**Subject:** Response to the NRCs Request for Additional Information RE: Westinghouse Electric Company Topical Report WCAP-16182-P-A, Revision 1, "Westinghouse BWR Control Rod CR 99 Licensing Report - Update to Mechanical Design Limits" (TAC No. ME2630) (Proprietary/Non-Proprietary)

**Response to the NRC's Request for Additional Information  
RE: Westinghouse Electric Company Topical Report  
WCAP-16182-P-A, Revision 1,  
"Westinghouse BWR Control Rod CR 99 Licensing Report -  
Update to Mechanical Design Limits" (Non-Proprietary)**

RE: REQUEST FOR ADDITIONAL INFORMATION (RAI)  
BY THE OFFICE OF NUCLEAR REACTOR REGULATION FOR  
WCAP-16182-P-A, REVISION 1,  
"WESTINGHOUSE BOILING WATER REACTOR CONTROL ROD CR 99 LICENSING  
REPORT - UPDATE TO MECHANICAL DESIGN LIMITS"  
WESTINGHOUSE ELECTRIC COMPANY  
PROJECT NO. 700

**Figure 7.** Finite element model used for the absorber blade stress calculations.

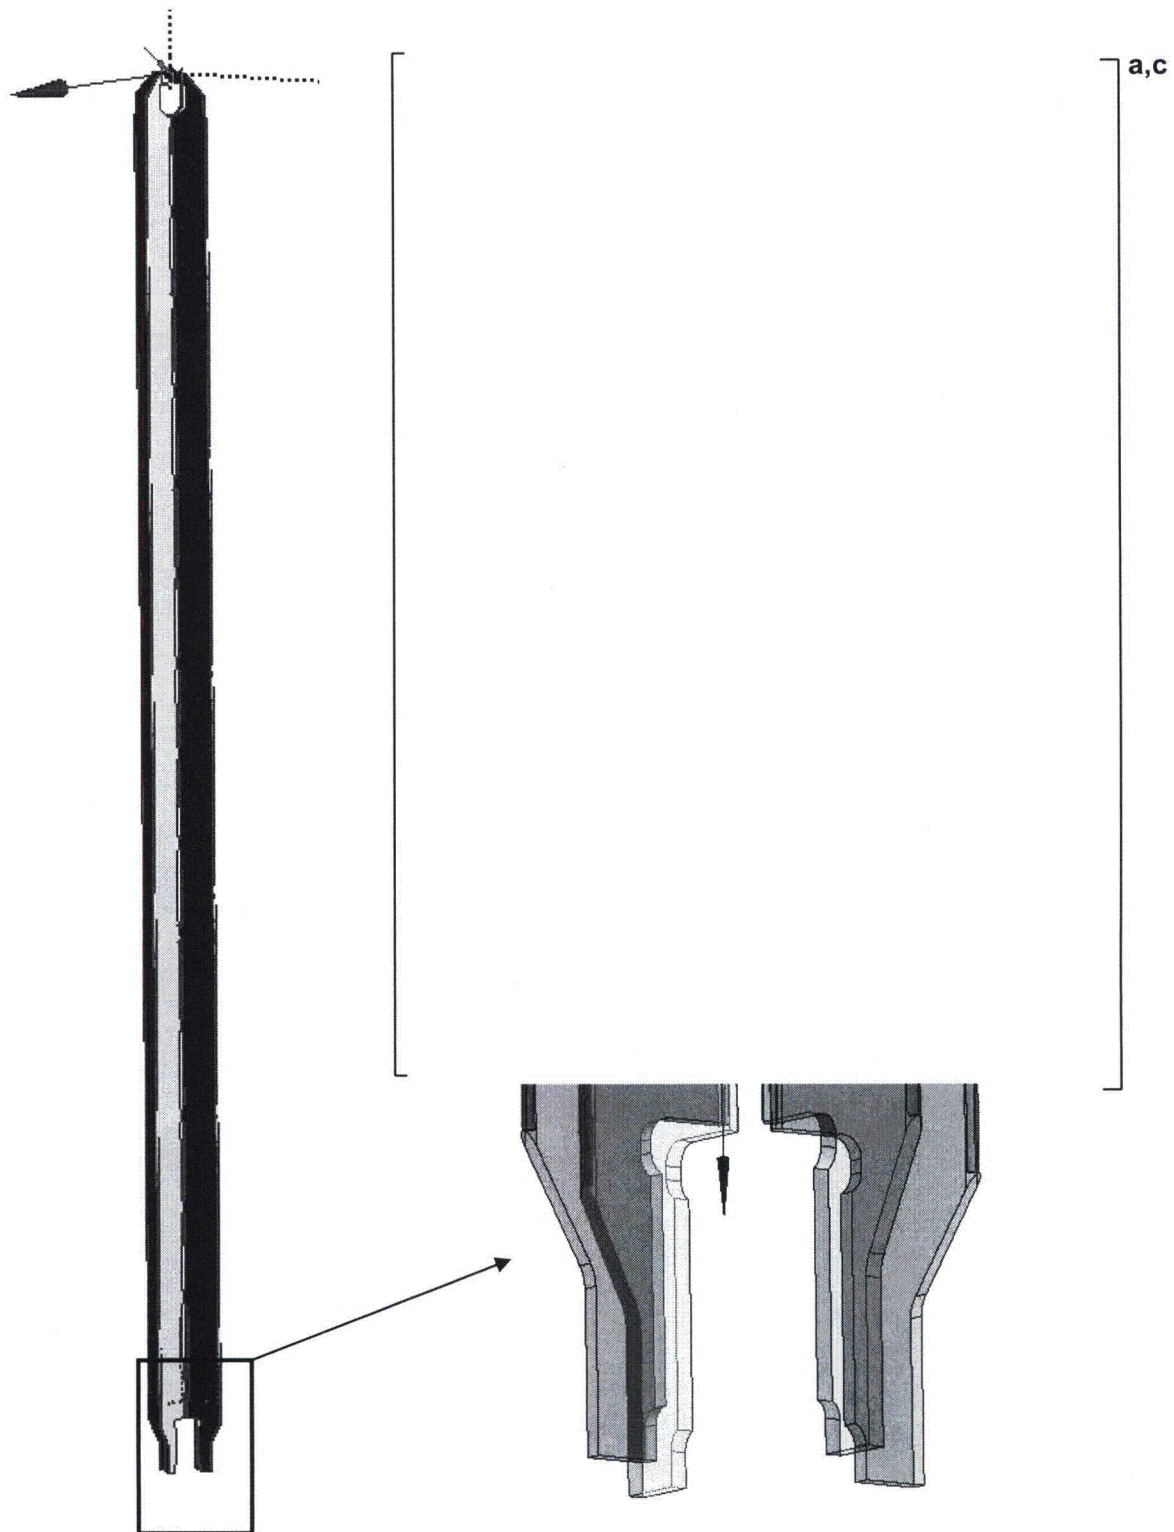
- b. Explain and justify the symmetry assumptions and the particular geometry used in the FEA models. Figure 6-4 appears to be a half-symmetry model of a single absorber hole, sectioned horizontally through a control blade wing. However, the original document (WCAP-16182, Rev. 0) indicates that [ ]<sup>a,c</sup> so it is not clear which absorber hole was chosen for analysis or why it was chosen. [ ]<sup>a,c</sup>

The cross section with largest  $P_m$  is identified as the critical cross section. This cross section is modeled and analyzed with the finite element system ANSYS.

Conservative geometry assumptions are used in the finite element model. Tolerances are chosen so that a minimum cross sectional area is used, with minimum blade thickness, maximum hole diameter and length, and maximum shoulder height. Minimum specified ligament thickness is used in the finite element model and the cross section through the ligament is constrained to constant axial deformation. The cross section through the absorber hole is constrained to zero axial deformation. These constraints are used because the critical load combination is scram force superimposed to internal Helium pressure.

Figure 7 and Figure 8 are shown in order to explain the finite element model used in the calculations of the absorber blade.
